**MIL-HDBK-516C CHANGE NOTICE No. 516CN-5**

## Ejection Injury Criteria

### 9.1.1 Escape system safety compatibility.

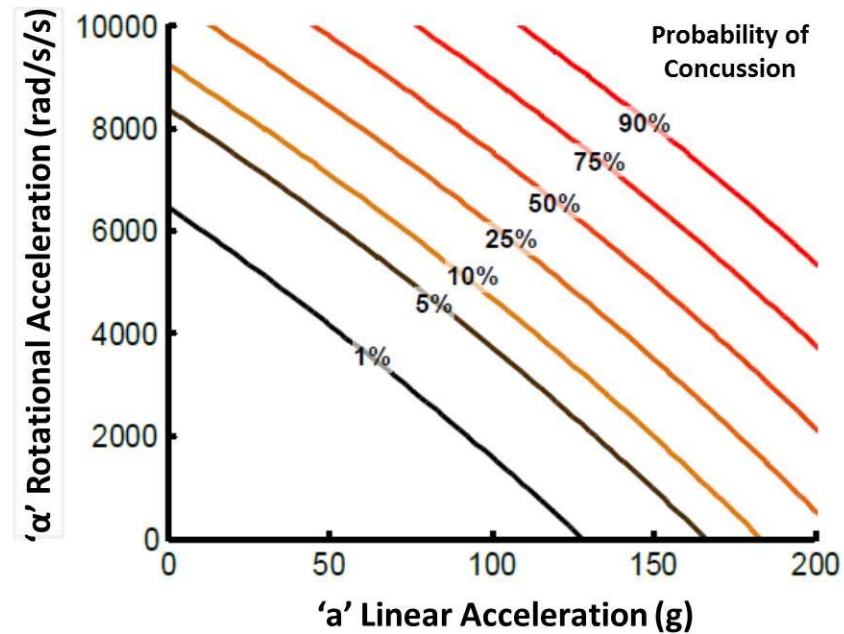
- **Limits Multi-axis Dynamic Response Criterion (MDRC) to 1.0 (5% AIS 2 injury risk) up to 450 KEAS.**
  - DRz limits for the MDRC calculation (similar to DRI limit) is not changed (from 18 to 16) due to interrelationship with MDRC terms.
  - MDRC applied all the way through parachute full open; transitioning from seat to manikin lumbar accelerations at seat/aircrew separation

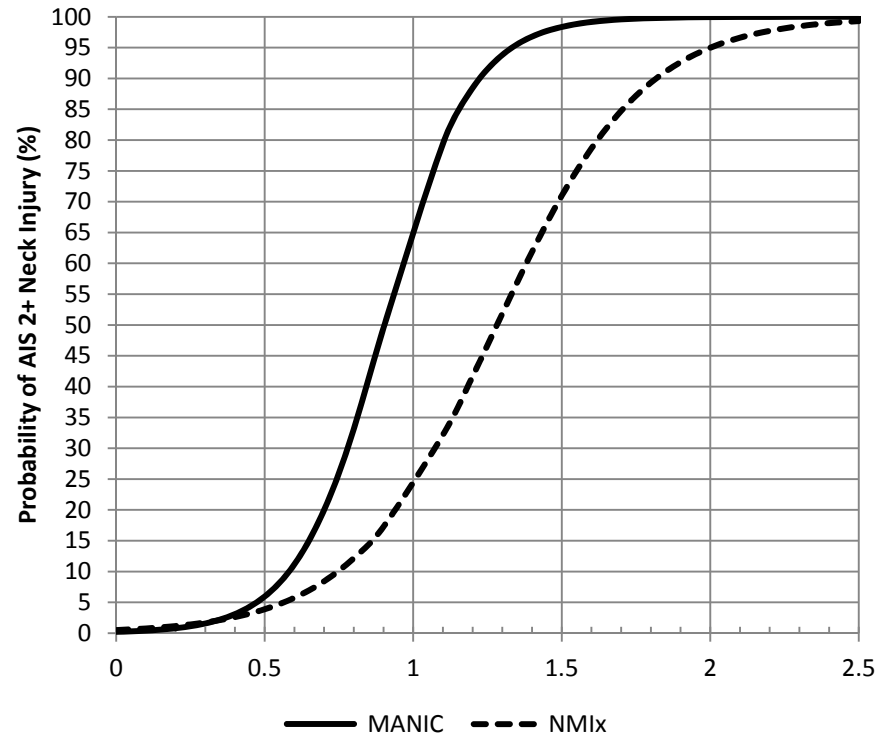
- **Added stability criteria for seat pitch & yaw**
  - **+/- 20° pitch and positively damped at all speeds through rocket burn out for systems with head supported mass greater than shown in EZFC-CSB-16-001**
  - **+/- 20° yaw and positively damped above 250 KEAS (current state-of-art does not include low speed yaw control capability)**
- **Added requirement for limb restraints on systems faster than 300 kts**
  - **Legacy data showed increase injury rate with airspeed and 5% risk at about 300 kts.**
